## NOTICE OF APPROVAL

**Planning Case #:** Design Study 24162

**Project Description:** This approval of Design Study (DS 24162 (Turner)) authorizes amendments to existing Design Study Approvals (DS 20-196) for alterations to an existing single-family residence located at Mission 5 NW of Santa Lucia in the Single Family Residential (R-1) District. The modifications approved under this Design Study include: 1. The addition of a new stone veneer to the East and North Elevations of the property; 2. The relocation of a window from the North side of the property to the South side; 3. The addition of a window to the upper level of the South side of the property; 4. The replacement of the proposed horizontal picket and plaster column fencing with vertical wood picket fencing; 5. The replacement of the proposed standing seam metal roof with composite shingles. Alterations not expressly listed in this authorization are not permitted. The project shall be consistent with the plans dated approved by Community Planning & Building Department on August 20, 2024, unless modified by the conditions of approval contained herein.

**Project:** DS 24162 (Turner)

WEST ELEVATION

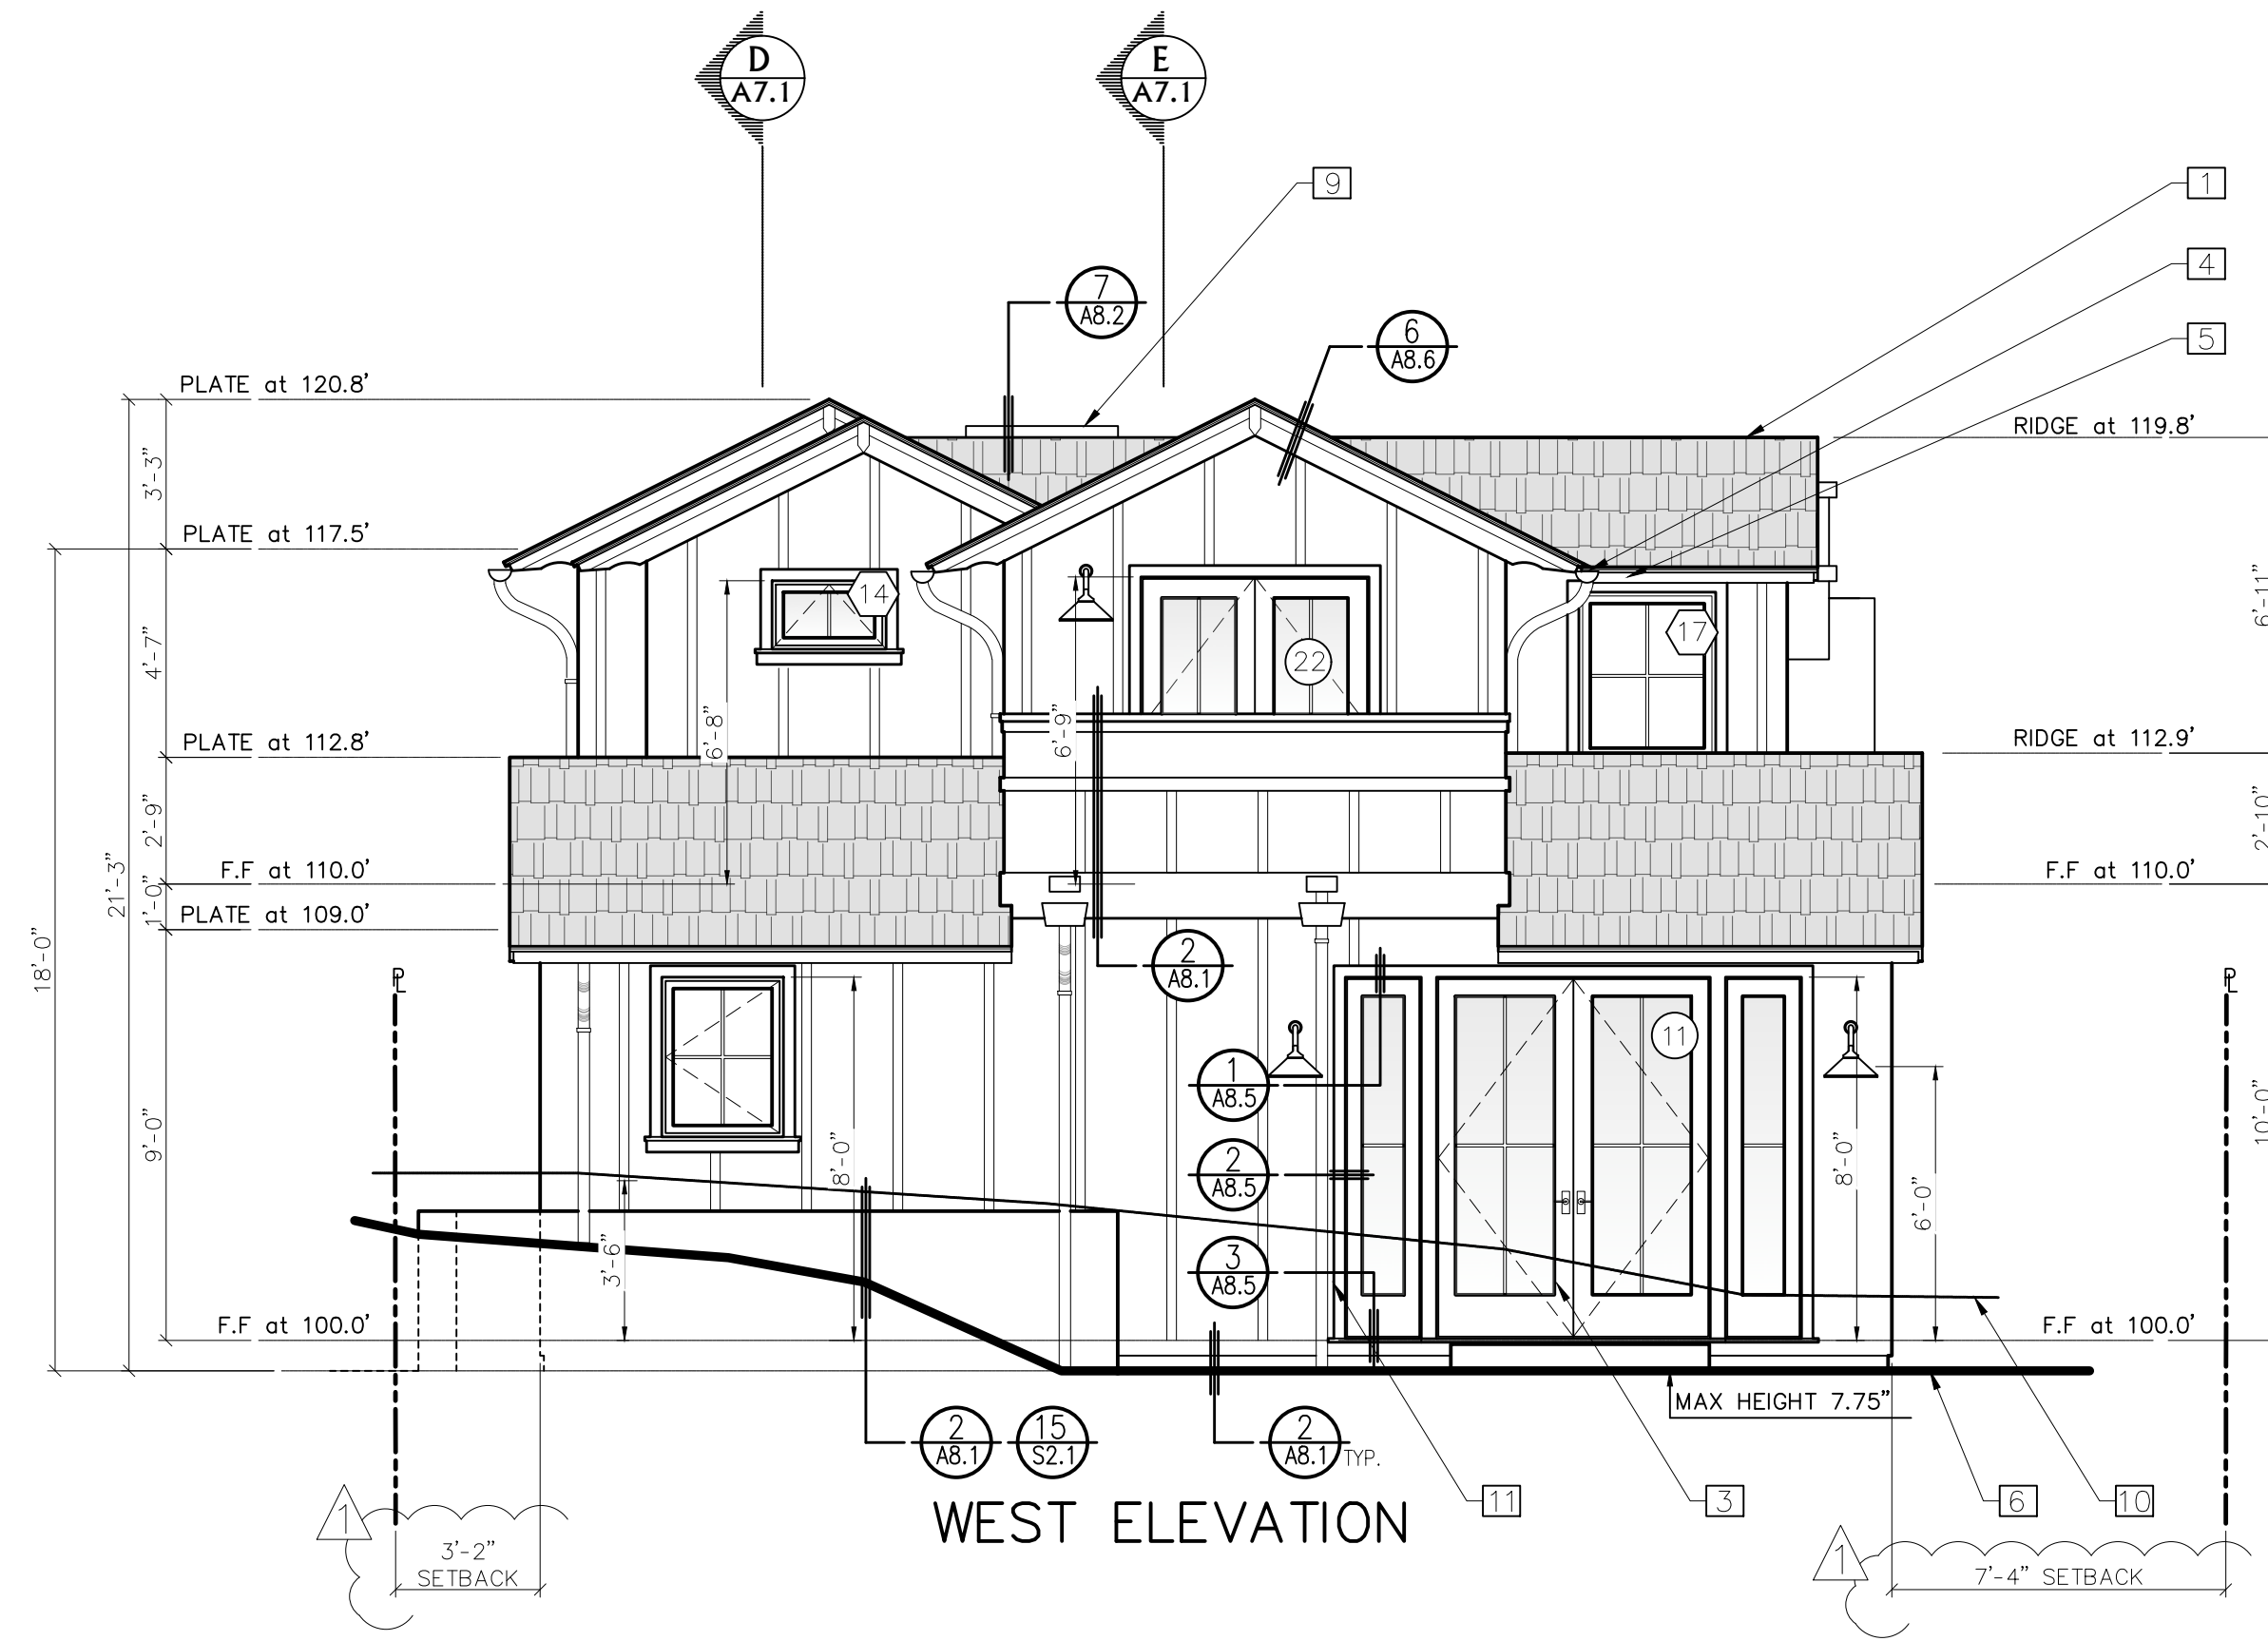
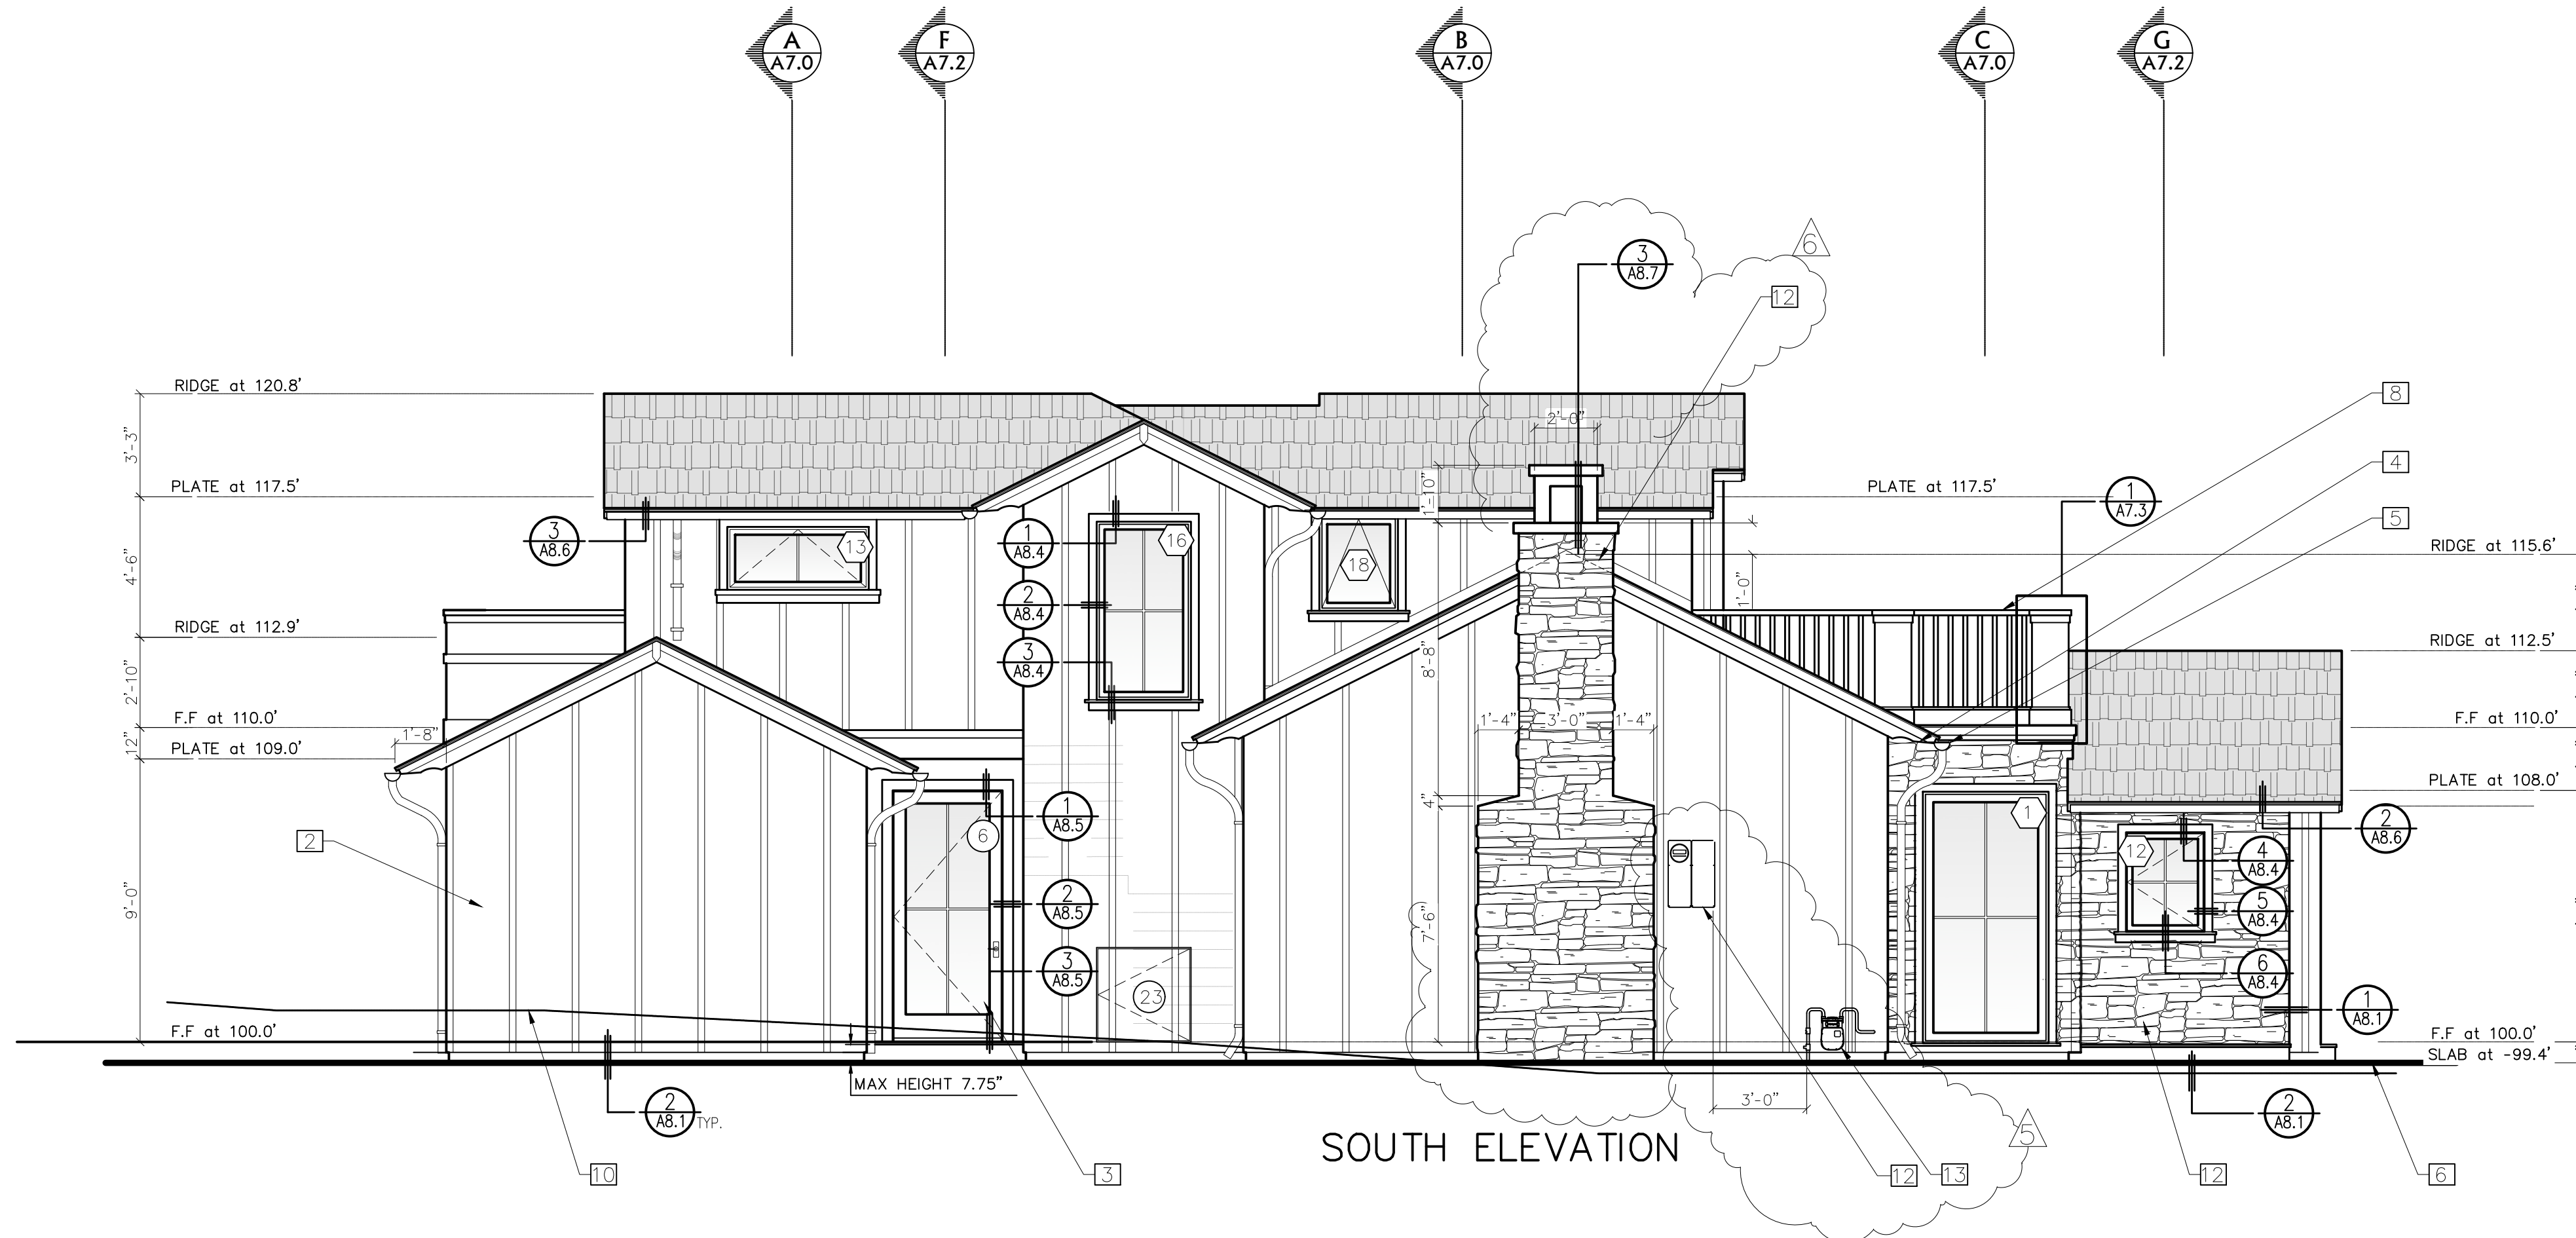
- REV 05/25/24
1. MOVED WINDOW #13 TO THE SOUTH ELEVATION
  2. ADDED WINDOW #18 TO THE SOUTH ELEVATION
  3. REMOVED WINDOWS #2 & 3 FROM THE SOUTH ELEVATION
  4. ADDED MUNTINS TO THE WINDOWS AND DOORS
  5. ADDED STONE VENEER TO THE GARAGE

**NEW 4-FOOT FENCE RENDERING**

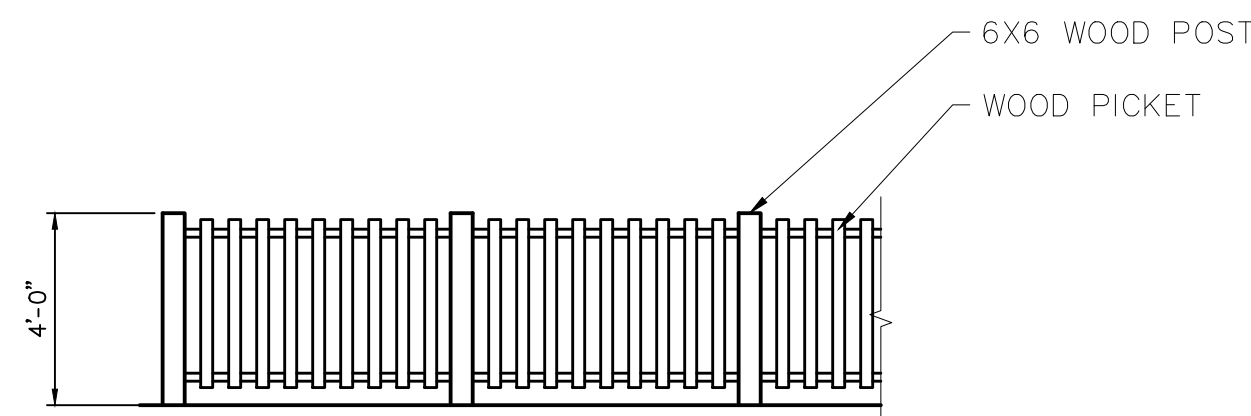
Please see original conditions of approval regarding lighting
